**Sherwood Uranium Mill Project
TECHNICAL EVALUATION REPORT**

Monitoring and Stabilization Plan Supplement

February 2000

Photo 5.

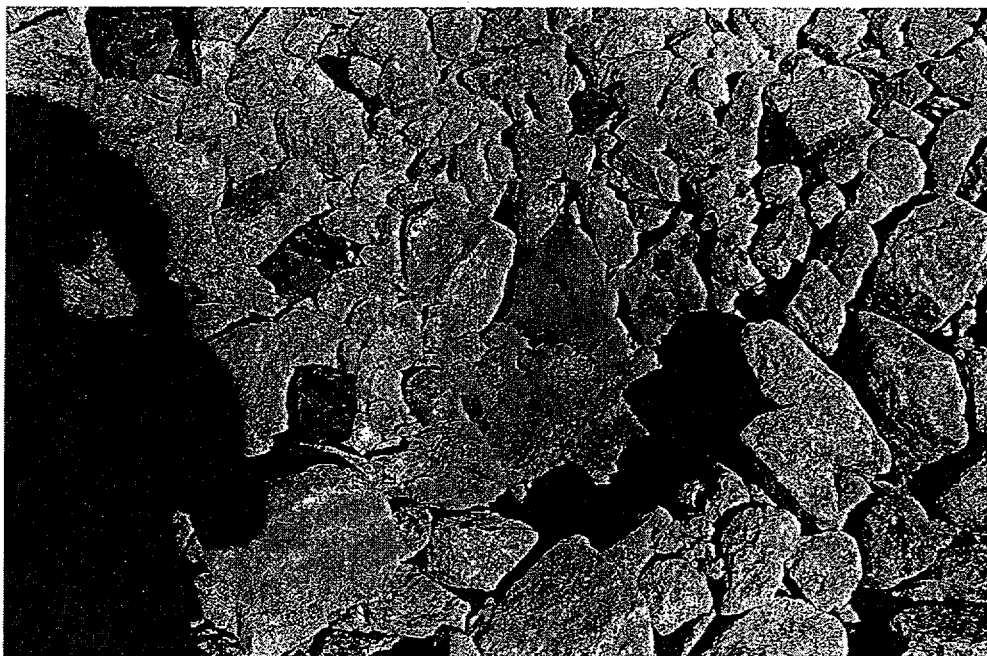
An area approximately 50 feet by 30 feet in the middle of the swale has patches where the big rocks (15 inch rock) appear to be concealed underneath a layer of smaller rocks that are 2-3 inches in size. The smaller rocks are not fragments of rock that has deteriorated, but represent the initial smaller rock fraction that was placed. This area appears to be more of a gradation question than a rock durability question. John Blacklaw dug a hole by hand, approximately 5 inches deep, until digging became too hard to proceed. John dug a second hole approximately 4 feet away from the first which did uncover the large rock. (Photos 5 and 6)

Photo 9.

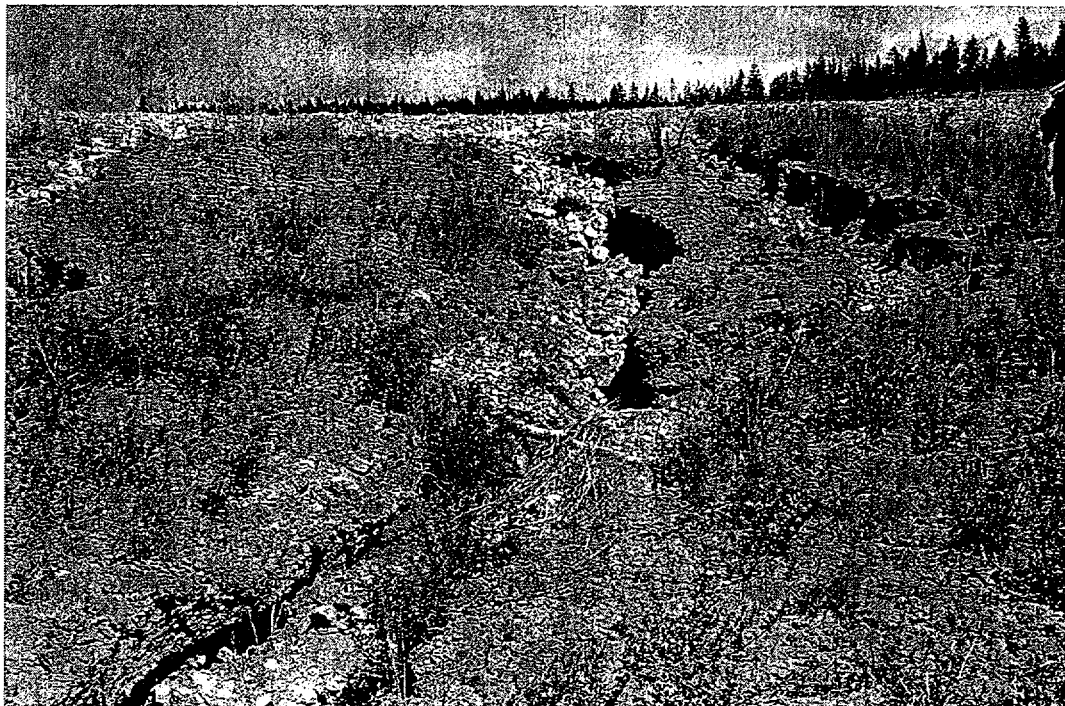
The topsoil has been removed by erosion in the gullies exposing the quartz monzonite bedrock underneath. (Photo 9 and 10.)

Photo shows where silty topsoil has been eroded away, exposing the quartz monzonite bedrock underneath.

Picture 4: Scarring in the channel walls

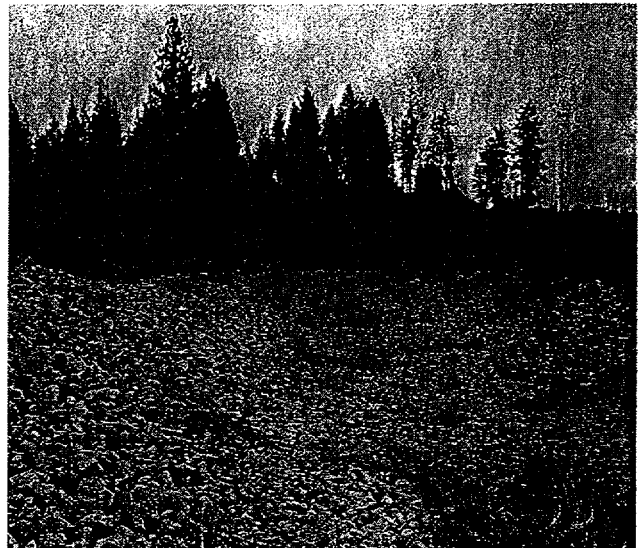
At Station 86+00, a thin area of riprap was noted (see picture 4). Station 86+00 corresponds to the first bend encountered during the inspection. The bend is approximately 30° to the left. Due to the channel width at this point, an apparent thin area was left in the outer diversion channel wall by the equipment used to excavate and build the diversion channel (e.g., scarring the wall). Again, vegetation has taken root where the thickness of the riprap is not uniform. Detailed investigation of this volunteer vegetation indicates that the roots are pervasive. It was with difficulty that the thickness of the riprap in these areas was determined.

Picture 13: filter visible through riprap
Size of "COHMED" notebook is 9.5 in x 12 in

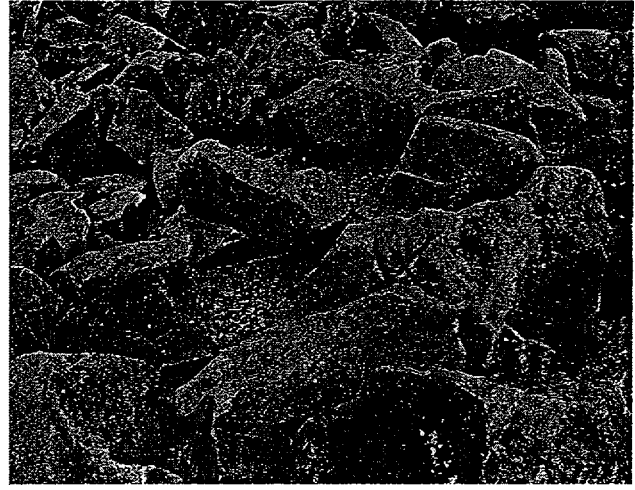
In Confluence B, there were spots, limited to about 1-2 ft², where the filter layer was visible. Additionally, as noted before, opportunistic vegetation had pioneered these spots. Pictures 13, 14 and 15 document these spots and surrounding area.

Picture 44: approximately 10 ft² of voiding in the riprap layer in an otherwise good placement area at Station 15+79.

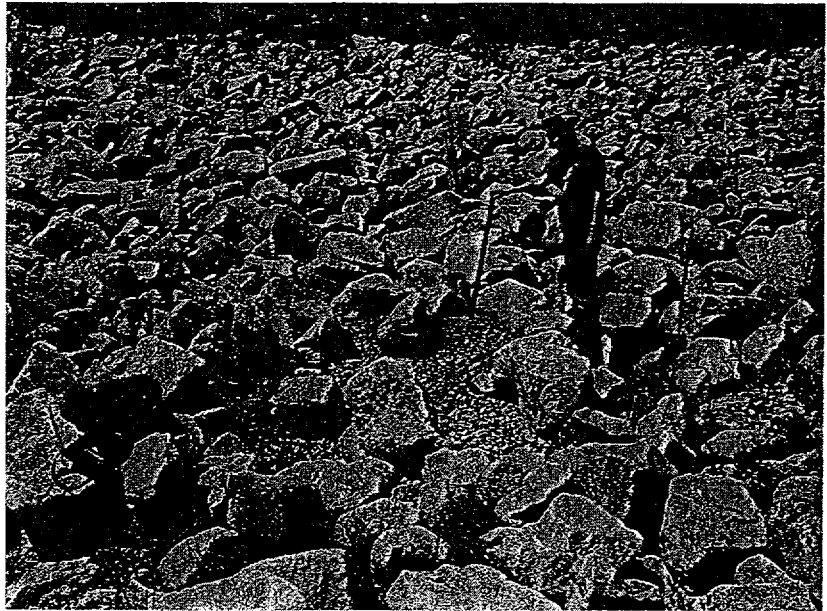
Areas that appeared to be lacking in the requirements for riprap were investigated. Picture 43 is an example of a suspect area. Upon examination, this area was found to be at least 23 inches deep of various size rock surrounding some large ($D_{50} \approx 15$ inch) rock. In essence, the area had developed into a rock mulch layer. Technical literature (e.g., NUREG-1623) has documented that a rock/soil matrix (riprap layer with the rock voids filled with soil) has similar stability characteristics as the riprap layer alone.

Swale Outfall Gully Erosion Issues

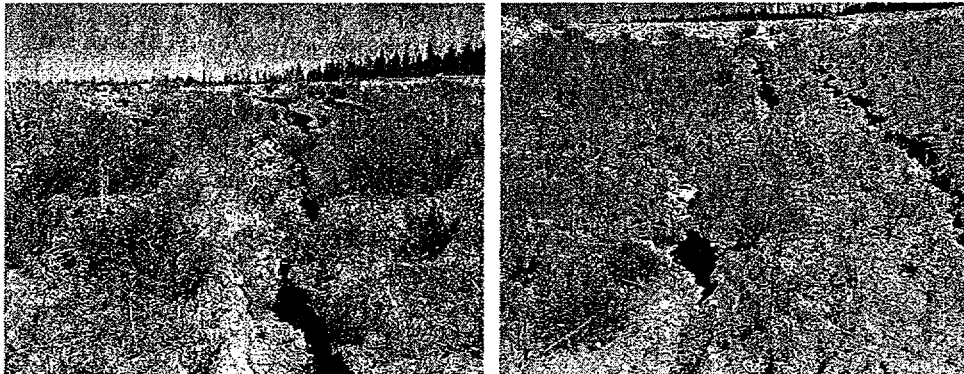
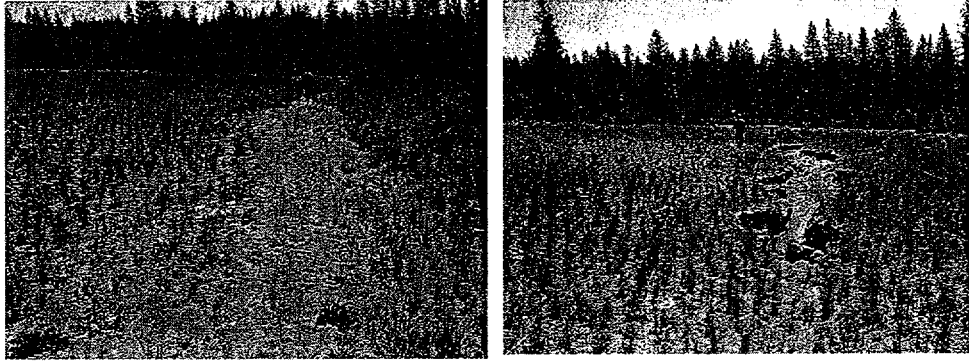
The beginning section of the first swale bench is silted nearly full and will overtop with significant surface water flow from the swale outfall. This potential occurrence would likely produce concentrated flow and formation of a gully. The flow would then pass to the second bench (located about 100 feet to the south, down-slope, and parallel to the first bench) where the flow would be collected and slowed again causing silt deposition. The second swale bench would progress in a similar manner to the first swale bench until it fills with silt, overtops, produces a concentrated flow path and forms gullies further down stream. This would continue until a relatively stable configuration and flow pattern is

eventually produced after a few years. Eventually, these gullies may cut back through the fine-grained surface soils to the swale outfall structure.
